## **Design Schematics for a Sustainable Parking Lot**

**Building 2-2332, ENRD Classroom,  
Fort Bragg, NC**

## **Final Report**

Figure 22. Scheme C (not to scale) — both aesthetically and technically pleasing, but uses significantly more pavement.

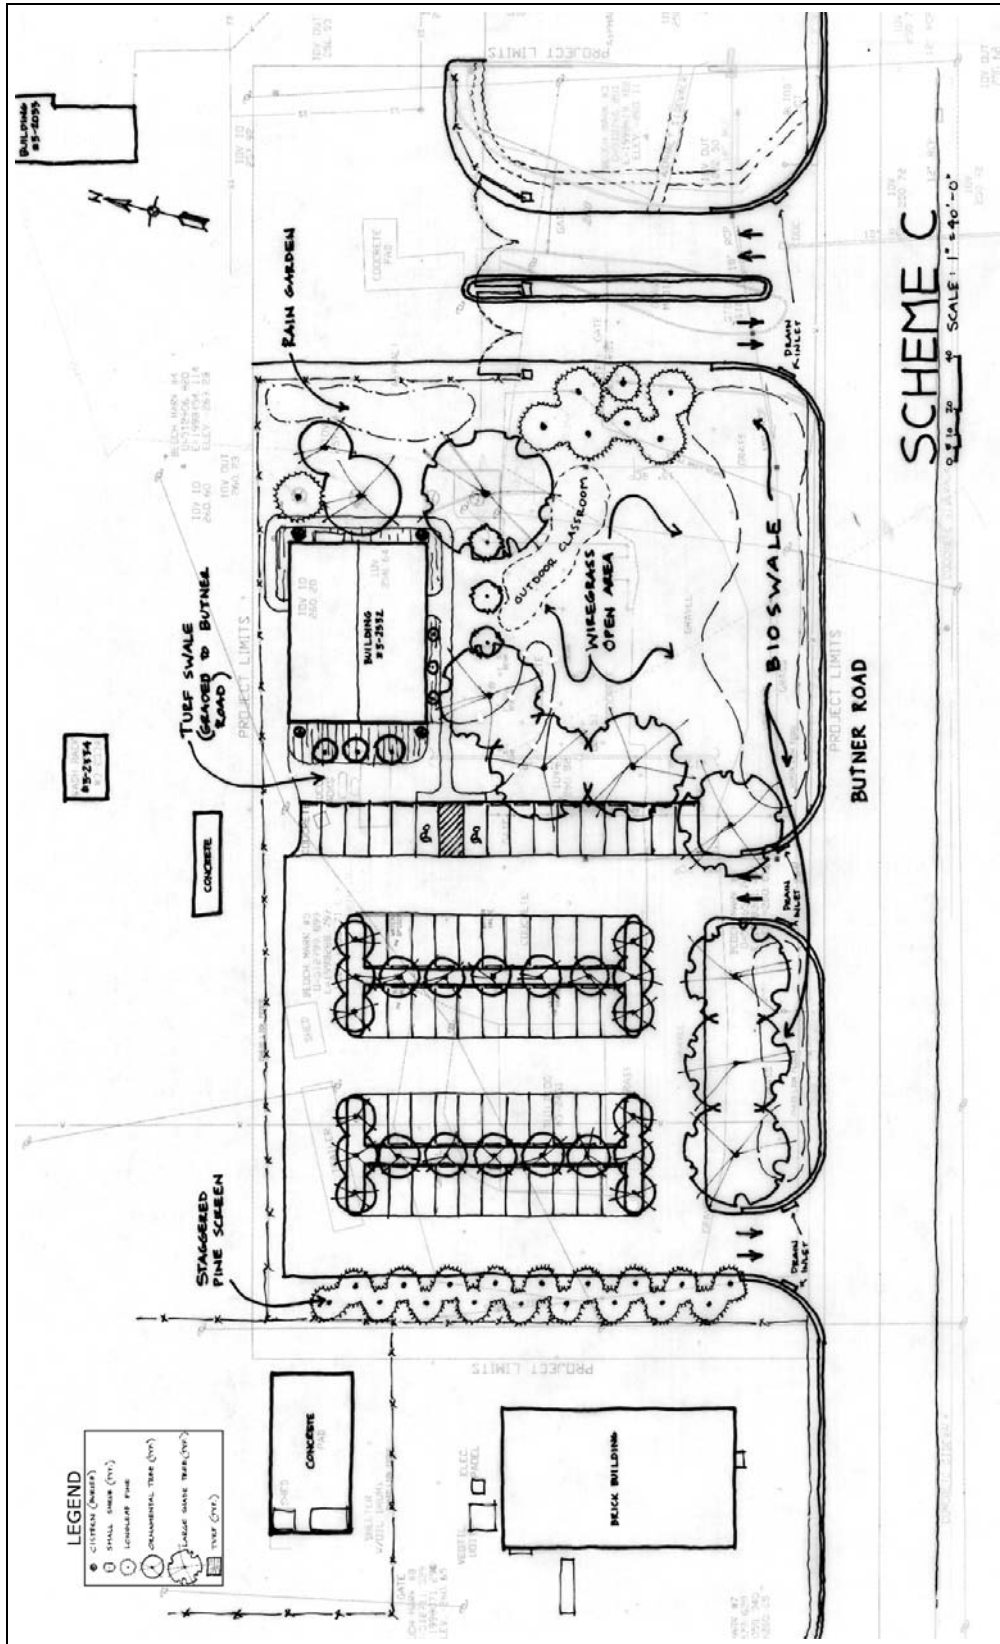
14. Scheme C – need to address pedestrian traffic coming from within the PWBC compound. Add a pervious walkway to the side or front door. Consider adding a sidewalk inside the fence.
